Elevation updates from previously approved application ref. 23/00335/FUL:

Project
Middleton

Drawing Title
Proposed South and West Elevations

Drawing Number
N0303-CSQ-XX-ZZ-DR-A-121

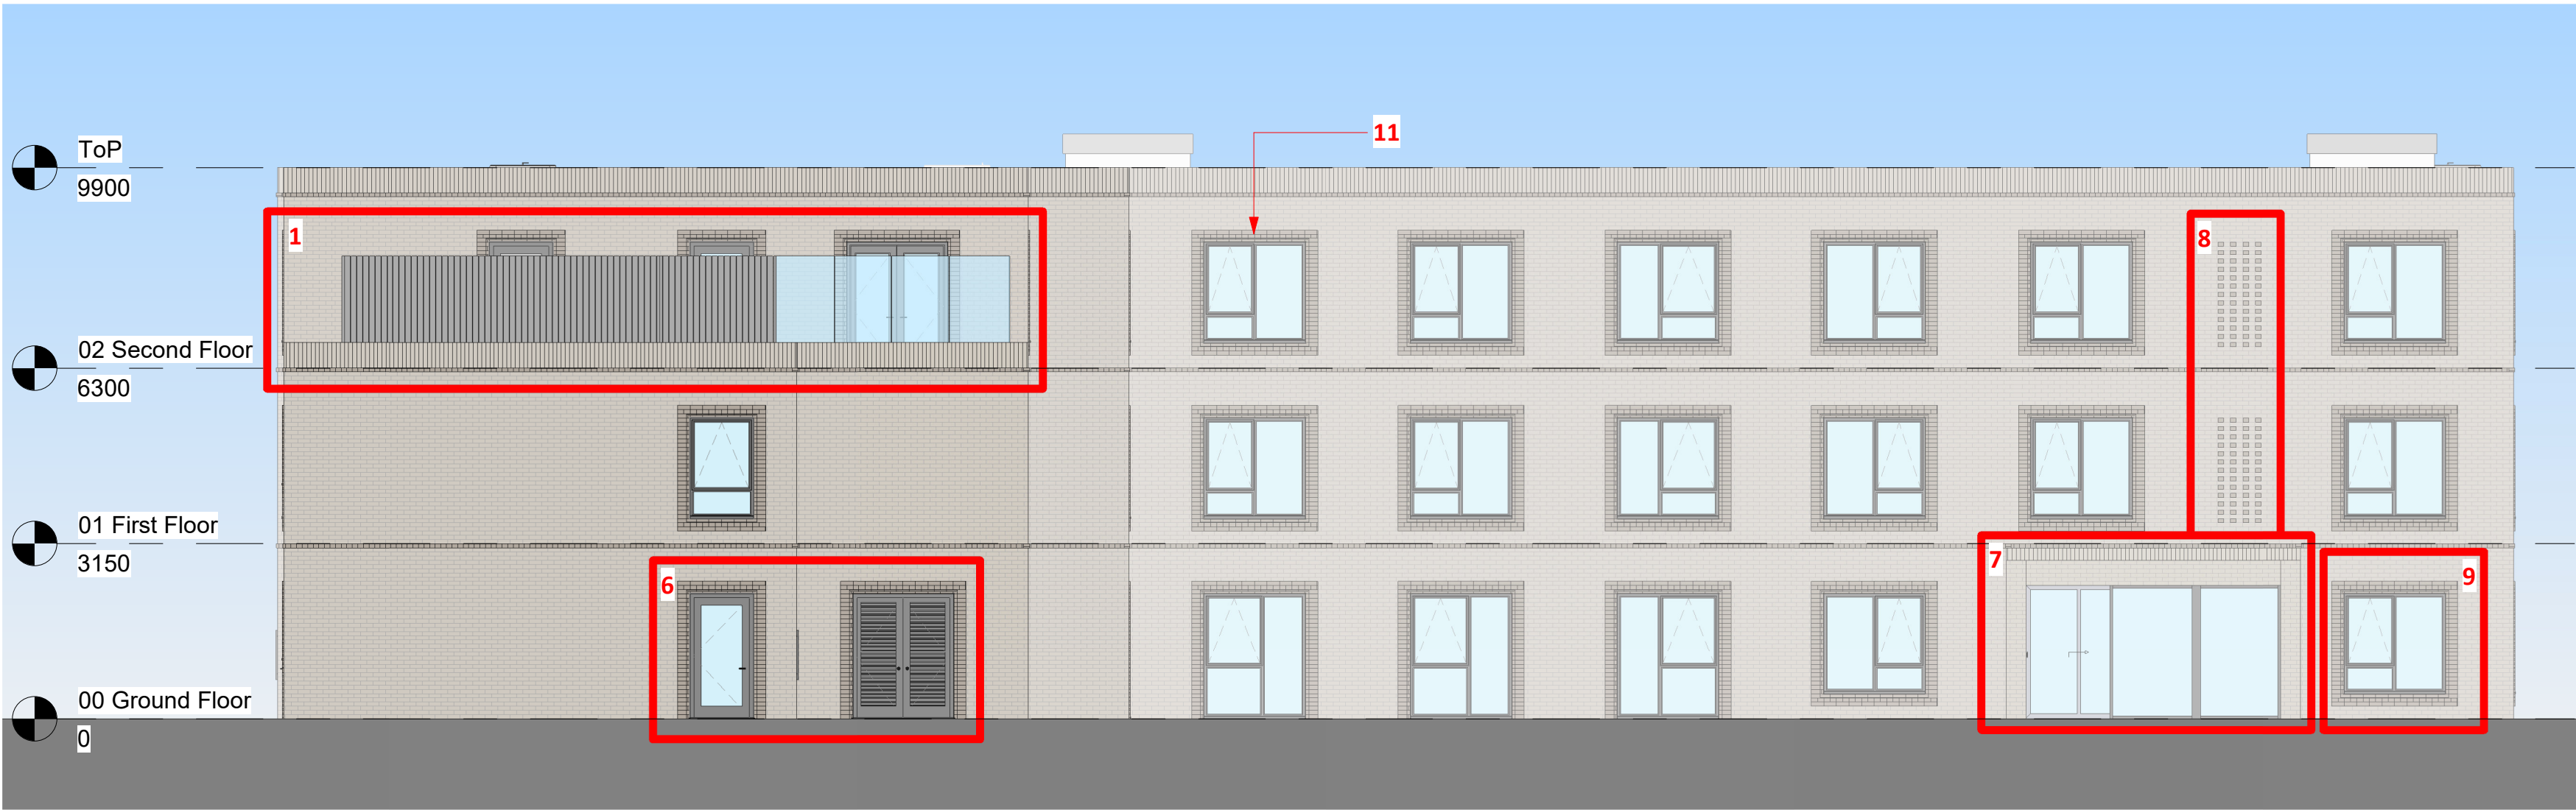
1. New external terrace with glazed balustrade above proposed flat roof. External plant to sit to the Northern side within an enclosure clad in fibre cement cladding

2. Westernmost staircase repositioned to meet means of escape compliance on the second floor. Brick detailing and glazing amended accordingly
3. External door into Southernmost stair core repositioned to suit internal layout changes

4. Window positions revised to reflect reduced width of stepped bays
5. Curtain wall glazing and brick detailing to stair core amended
6. New external doors to end of ground floor corridor and plant room

7. Single storey flat roof entrance design amended
8. Element of curtain walling replaced with brick detailing
9. External glazed door to Manager's Office replaced with a window

10. External glazed doors indicated to new ground floor bedrooms following internal layout changes
11. Build feasibility of window and door surrounds to be reviewed
